# 20:20 Building, Skinner Lane, Leeds

## Intrusive Survey of ACM Cladding Report

05218/JY/XX/50316/WL/01

Figure 2- AOCA proposed detail

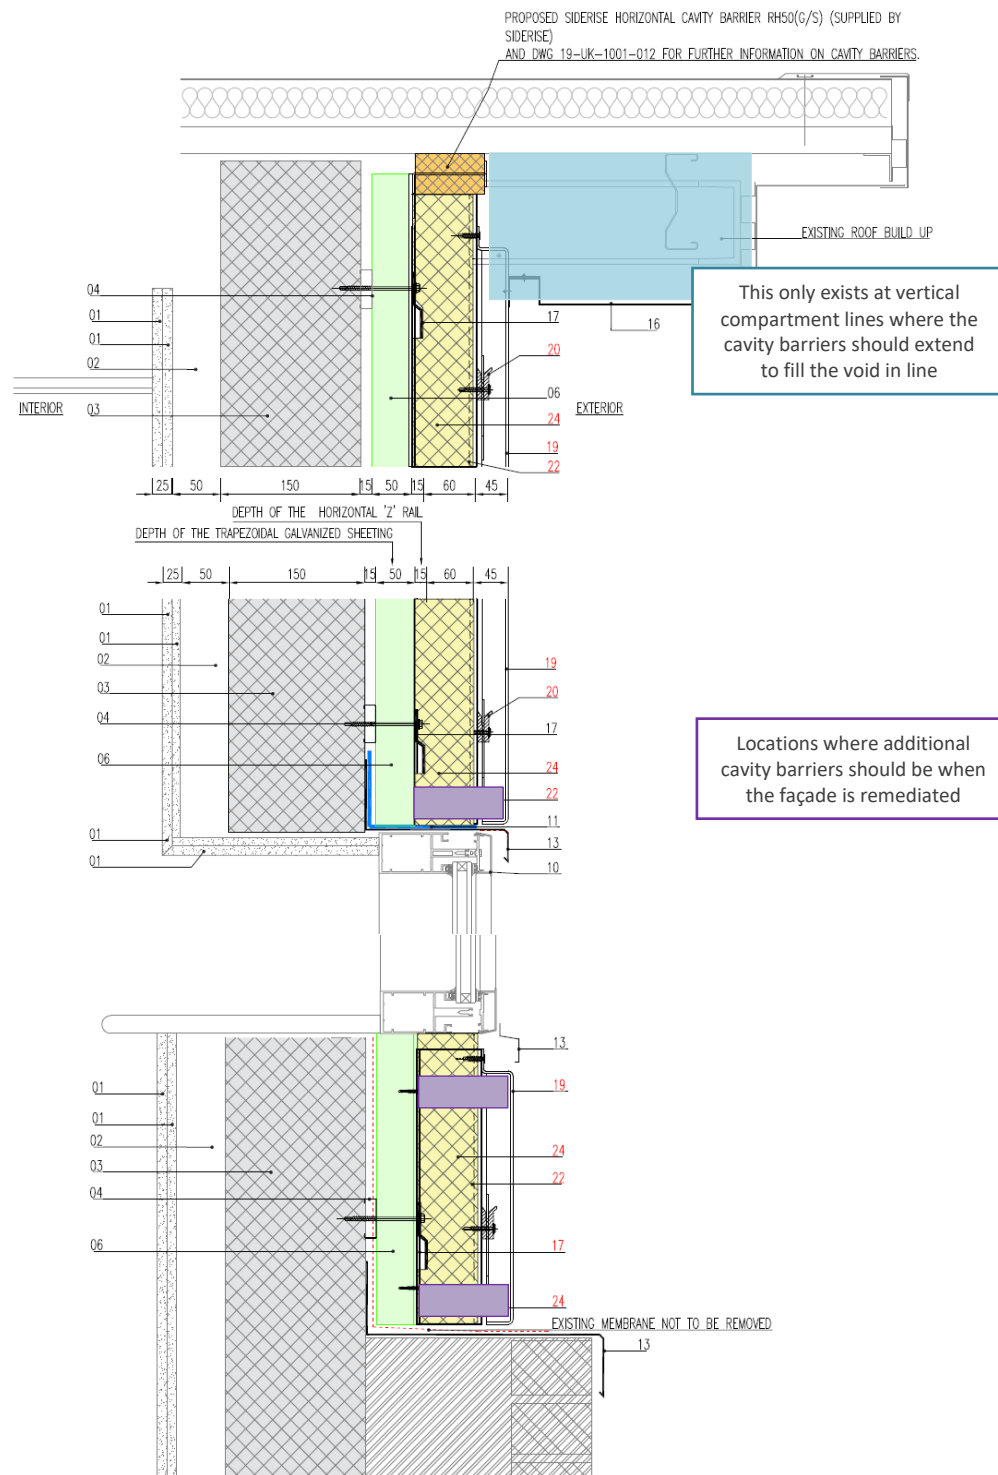
- 10.4.1 The drawing do not clearly define the primary and secondary wall construction; therefore, the elements which fasten to the sheet is not clear. This needs to be identified in order to determine the suitability of the existing construction.

- 10.4.2 It appears that the previous cladding system is completely supported onto the trapezoidal corrugated sheet. The newly proposed system will increase the weight of the façade system and should be verified by calculation.

- 10.4.3 The corrugated trapezoidal sheet stops short at the top of the detail where it interfaces with the roof and at the bottom which means this may not perform a number of functions relating to acoustic performance, thermal/condensation performance and fire performance. A strategy for sealing these areas to meet the necessary performance should be devised if the sheet is to remain part of the construction.

- 10.4.4 A cavity barrier is shown at the top of the proposed detail. Whilst a cavity barrier should be provided at edges of compartments, further cavity barriers may be required above and below the window and at the edge of the cavity. Vertically, full fill cavity barriers should be used; horizontally, open state cavity barriers with an intumescent face that will expand to the rear face of the aluminium panel when activated should be used or a sleeved, full fill cavity barrier whose durability has been proven to not be compromised by the presence of water. Given the shape of the trapezoidal corrugated sheet, assistance from the manufacturer in relation to the installation of the barriers with this form of sheet should be sought. Refer to Figure 1 below.
